# Access Compliance Report

## Public Rights-of-Way

### (Curb Ramps)

Intersection ID: 31209	Main Street: CAPRINGTON_AV	Cross Street: CLACKWYCK_LN	Location: W
ADA ID: 5B8F00615EFC	Ramp Type: Perp	Initial Pass/Fail: Fail	Overall Compliance: No
Severity Score: 12.5			
Codes/Mitigation Info/Possible Solution		Field Measurements/Component Compliance

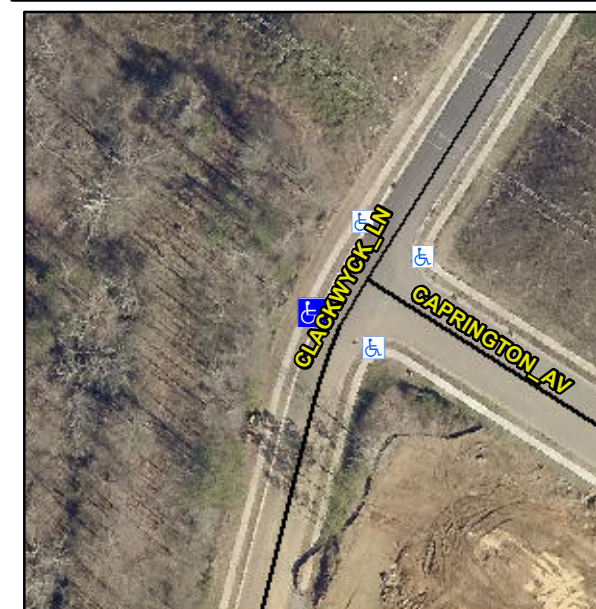
**Not Found, R304.5.3**

Compliance	Description	Data	Compliance	Description	Data
N/A	Ramp Length (in)	59.0	Yes	Ramp Slope (%)	6.5
Yes	Ramp Width (in)	53.0	No	Ramp XSlope (%)	5.4
N/A	Flare Type LT	N/A	N/A	Flare Type RT	N/A
N/A	Flare Slope LT (%)	N/A	N/A	Flare Slope RT (%)	N/A
N/A	Flare Traversable LT?	N/A	N/A	Flare Traversable RT?	N/A
N/A	Landing Length (in)	N/A	N/A	DWS Provided?	N/A
N/A	Landing Width (in)	N/A	N/A	DWS Contrast?	N/A
N/A	Landing Slope (%)	N/A	N/A	DWS Length (in)	N/A
N/A	Landing X Slope (%)	N/A	N/A	DWS Full Width?	N/A
N/A	Landing Curb? (Y/N)	N/A	N/A	DWS Offset (in)	N/A
N/A	Shared Landing?	N/A			
N/A	Gutter Ponding?	N/A	N/A	Gutter Slope (%)	N/A
N/A	Gutter Lip Ht (in)	N/A	N/A	Gutter X Slope (%)	N/A
N/A	Painted X Walk1?	No	N/A	Painted X Walk2?	N/A
	X Walk 1 Direction	To SE		X Walk 2 Direction	N/A
N/A	X Walk 1 Width (in)	N/A	N/A	X Walk 2 Width (in)	N/A
	X Walk 1 Slope (%)	5.7		X Walk 2 Slope (%)	N/A
	X Walk 1 X Slope (%)	2.3		X Walk 2 X Slope (%)	N/A

**Remove & Replace Entire Ramp.**
